Development Management Sub Committee

Wednesday 9 February 2022

**Application for Planning Permission in Principle
21/03757/PPP
at Western Harbour, Western Harbour Drive, Edinburgh.
Go Green hub and education centre including EV enabled
parking, cycle parking, e-bike hire, public transport
information displays, public realm and associated
infrastructure.**

II. Consideration of the City Mobility Plan Policy Measure Movement 19 - Mobility Hubs and their key elements is as follows:

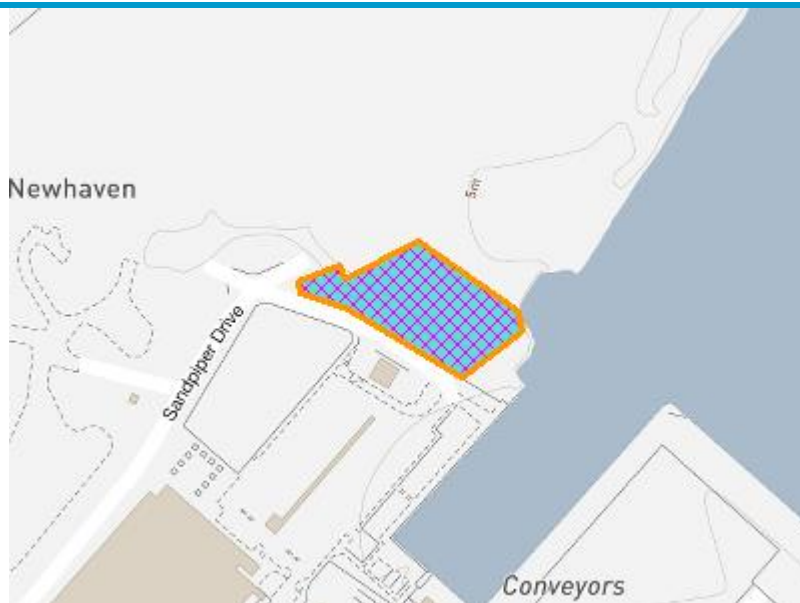
a. Co-location of public transport and shared transport (at least one or more public transport mode; and one or more shared transport mode such as car club, bike and mobility scooter hire) - The proposed Go Green Hub will be located approximately 380m (a 4-5 min walk) north of the proposed tram halt and the existing bus stops on Lindsay Road that are served by multiple bus services. Bus stops within Western Harbour are served by a Lothian Bus Service (no10) and are slightly closer to the proposed hub which also includes provision for car club and bike hire. Whilst it is understood that certain aspects are out with the control of the applicant the proposed location of the hub is not considered acceptable as it should be sited closer to the Tram and bus stops on Lindsay Road to maximise the ease in which to interchange between transport modes. The proposed location also would likely only provide service for the residents of Western Harbour and provide very little service to the existing residents and communities on the southern side of Lindsay Road;

- b. Provision of travel information, which is clear and visible - Travel information is proposed at the Sandpiper Drive junction, this information would need to take account of the additional walking time to Lindsay Road;

- c. Safe and secure bike storage and parking - Cycle parking is proposed as part of the Hub and is in a fairly prominent position which should provide some good passive surveillance. There would be an expectation for a fully secure and weatherproof shelter to house longer term cycle parking;
